Amendments to the Drawings

App. No.: 09/557,570
Title: MEMORY ARCHITECTURE FOR...
Inventors: Frank B. Manning
Replacement Sheet

FIG. 1A
PRIOR ART

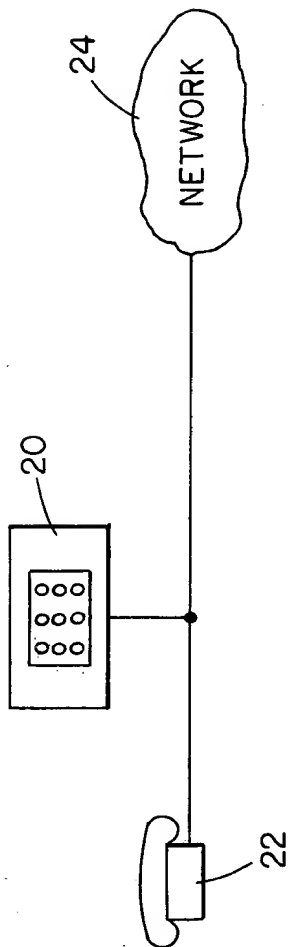
Figures 1A, 1B, and 1C were objected to as not being properly designated by the legend "Prior Art" according to MPEP § 608.02(g). We agree with the examiner's objection and hereby submit the necessary Replacement Drawings and corresponding Annotated Marked-Up Drawings in accordance with 37 CFR § 1.121 which include the required "Prior Art" legend in Fig. 1A, 1B, and 1C. Additionally, Fig. 7 is amended to included step labels "698" and "699" which were omitted from the original formal drawings.
